COUNTY ADMINISTRATOR'S OFFICE

June 6, 2017

Re: Rosemont Copper Mine, Section 404 Clean Water Act

Figure 6. Tetra Tech's (2010a) Figure 5, amended to show actual channel bed elevation at the location. Red line shows position of the 2008 and 2011 channel bed based on LIDAR data.

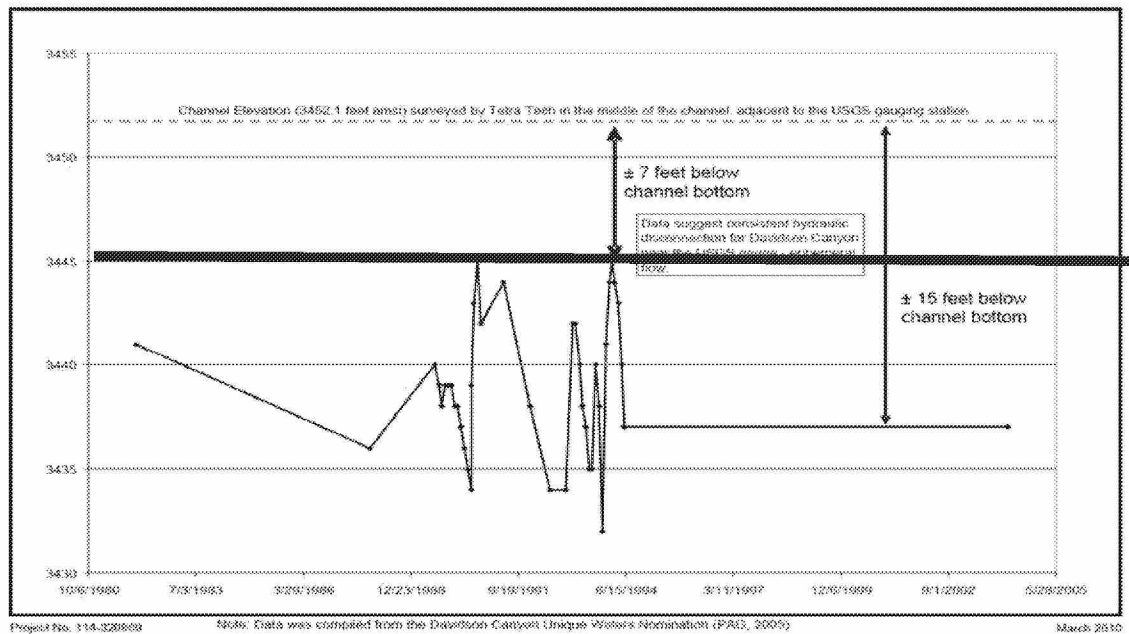
We also take issue with Tetra Tech (2010a) data. Underpinning Tetra Tech's assertion is an illustration and a channel bed measurement at the Davidson Canyon stream gage (Figure 6). The accuracy of this figure relies on a "mid-channel bed" measurement taken by Tetra Tech (2010a). We examined Pima County LiDAR-generated elevation data at the same location and found that Tetra Tech's "mid-channel" bed elevation is five feet higher than the channel bed in 2008. We then examined 2011 LiDAR bed-elevations at the same location, which rule out the possibility that five feet of aggradation occurred, as would be required by Tetra Tech channel bed measurement. Instead, the actual bed elevations in 2008 and 2011 vary by less than 0.6 feet (Figure 7). Thus, the actual channel-bed is within a foot or two of the water table as measured in Davidson #2 Well.

The water-level measurements presented by Tetra Tech came from the Outstanding Waters nomination submitted by Pima Association of Governments (2005), which identified this reach as intermittent. Tetra Tech (2010a) uses the same data to infer that this portion of the channel is ephemeral. It is unreasonable to assume that groundwater never could discharge to the surface, or that it has been persistently below the bed between 1994 and 2004, as is indicated by Tetra Tech with the horizontal line connecting the last two groundwater measurements (Figure 6). It is even more unreasonable to extend that inference to the entire upstream reach, as is done by Tetra Tech (2010a).

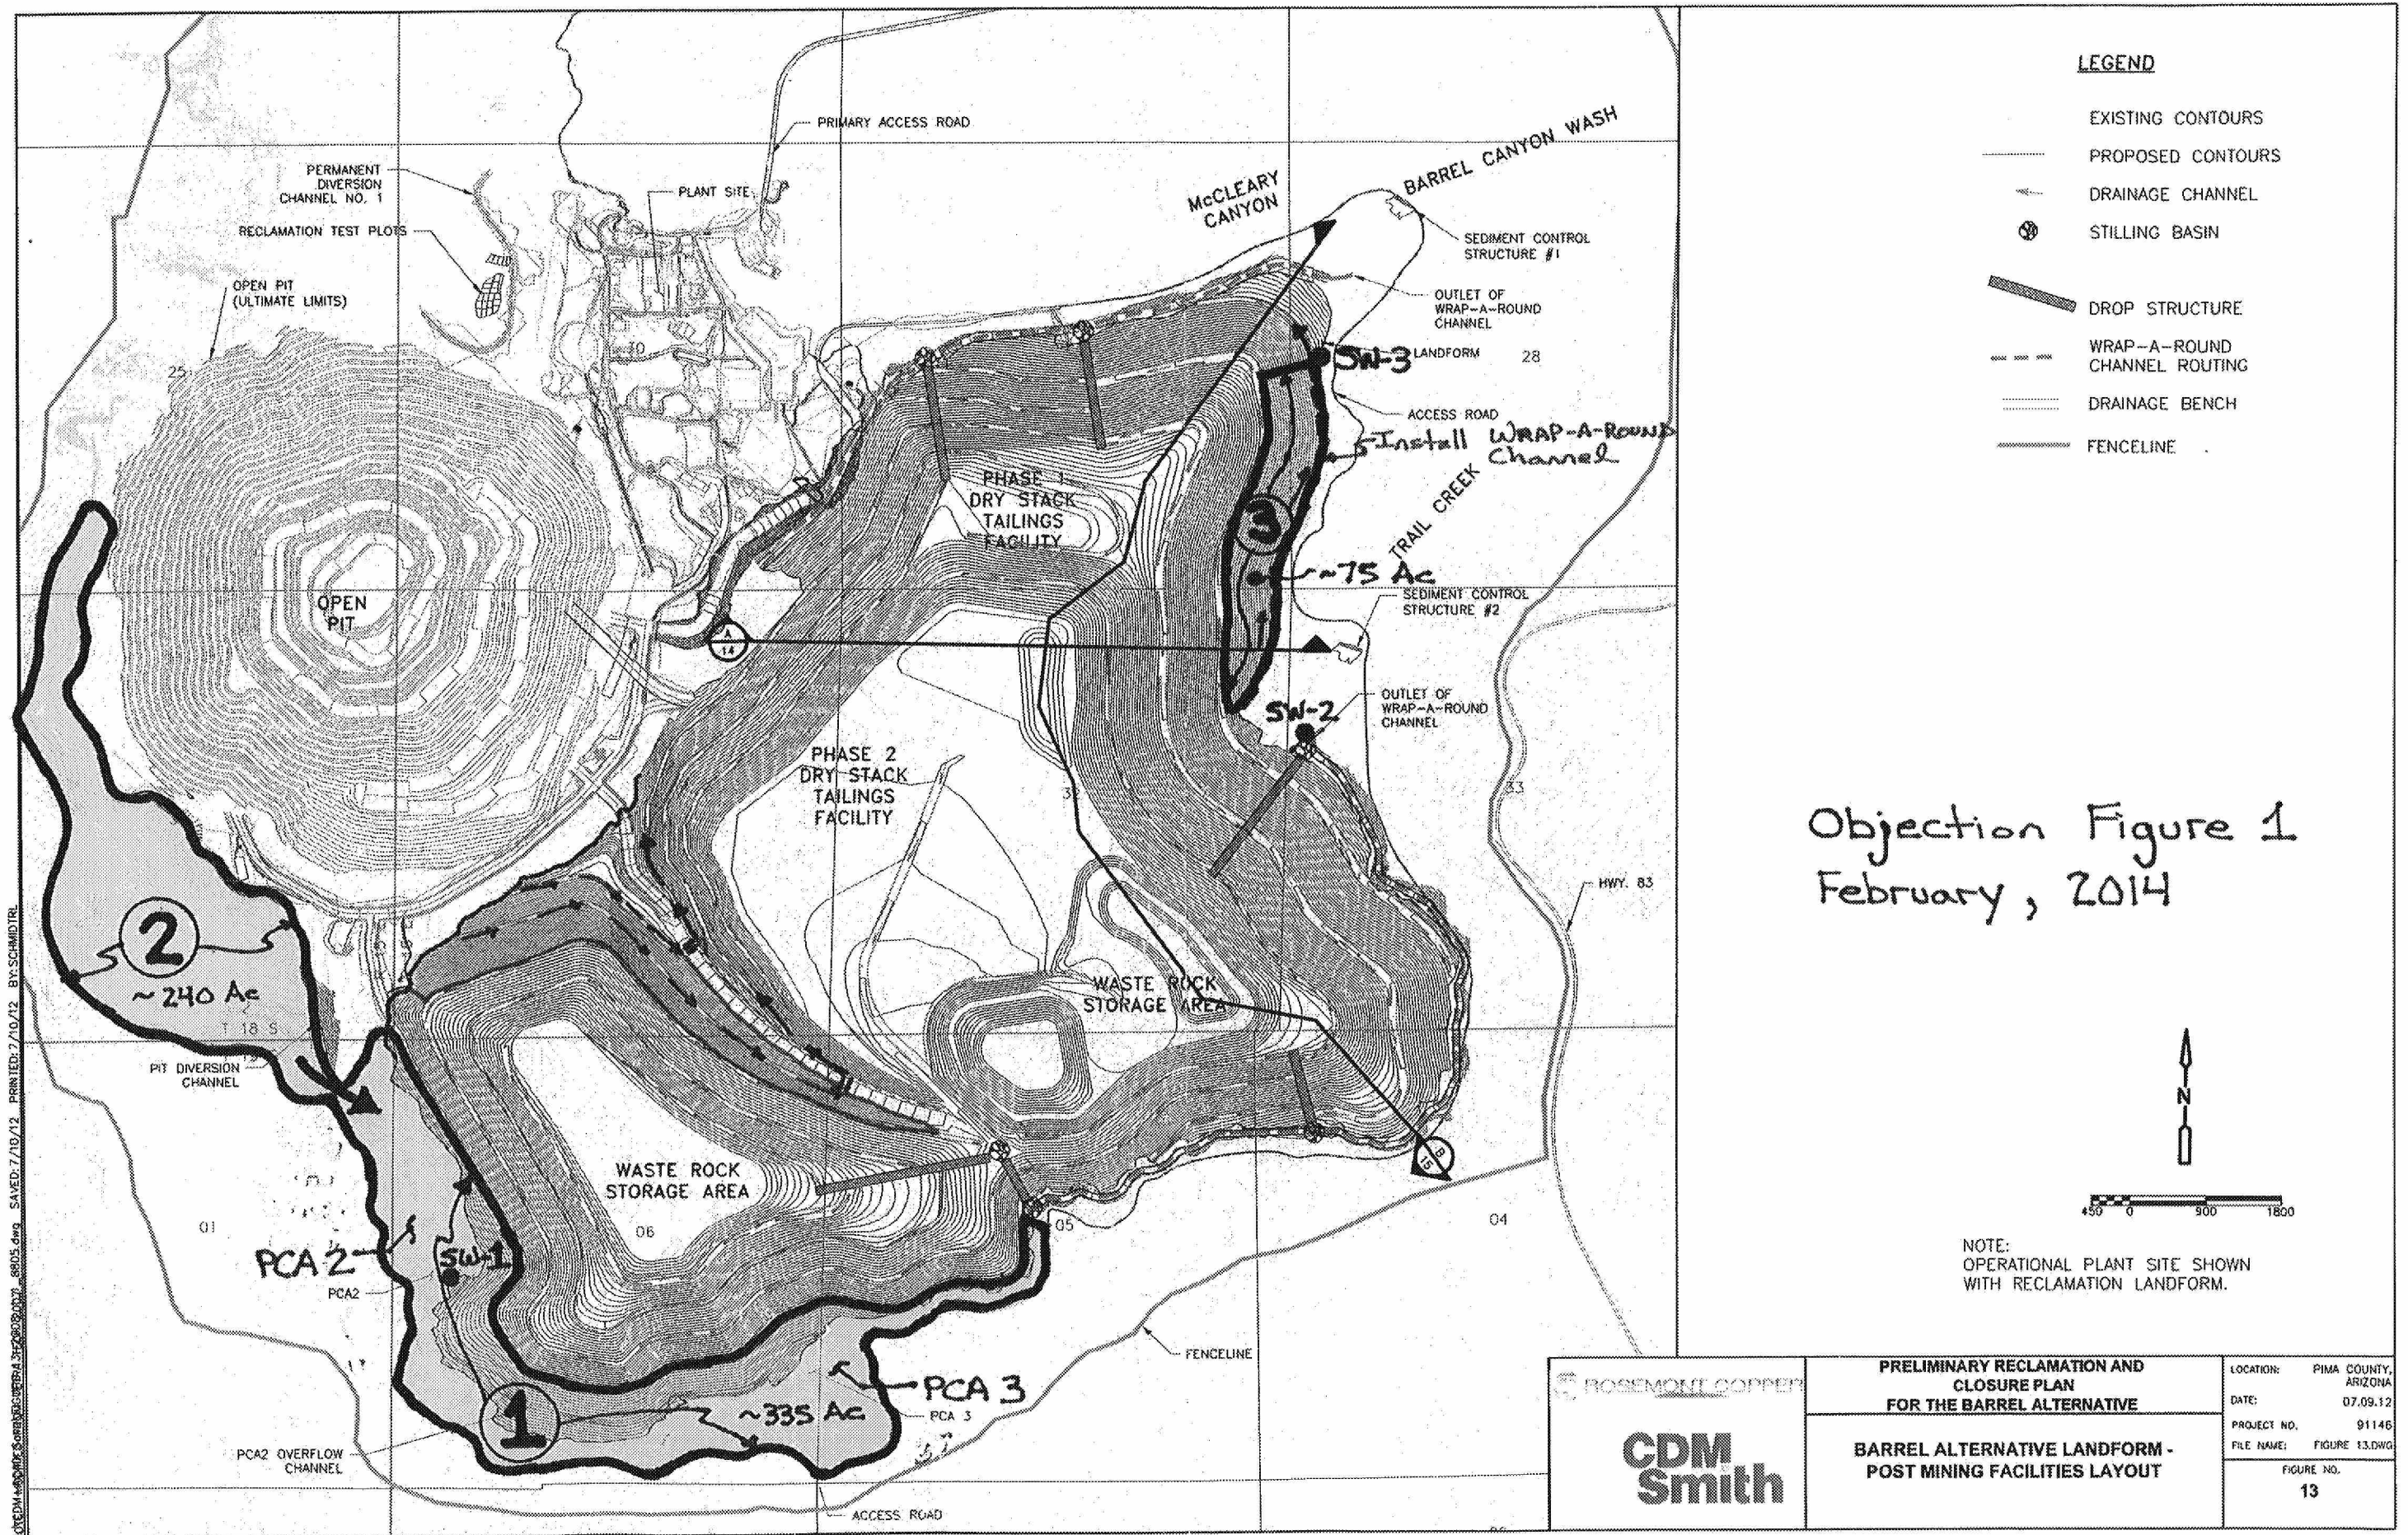
Rosemont Copper still intends to capture and retain surface water from an approximately 75 acre watershed area on the lower side slope of the northeastern portion of the tailings mound. This water should be released downstream into Barrel Canyon as part of the site water management plan.

As shown on Objection Figure 1, there is no collection channel planned to transfer water collected at the base of the Area 3 sideslope interval. An additional wraparound or perimeter channel should be constructed at this location along the northeastern side of the Tailings mound. Instead, stormwater collecting from this approximate 75 acre watershed side slope simply ponds along the base of the sideslope, within three main tributary areas below the adjacent north-trending ridgeline. This situation is similar in nature to the trapped water in PCA 2 and PCA 3 as described above in Objection 1.

The Forest Service should require Rosemont Copper to professionally design, and construct, an approximate 5000 ft long stormwater management channel along the northeastern perimeter of the Tailings mound to collect surface waters from the lower eastern side slope (Area 3 on Objection Figure 1). Surface waters collected along the base of this slope should be routed to the tailings mound side slope stormwater channel shown at location SW-3, for transfer into the northern Wrap-A-Round channel and release in perpetuity at the channel outlet into downstream Barrel Canyon.
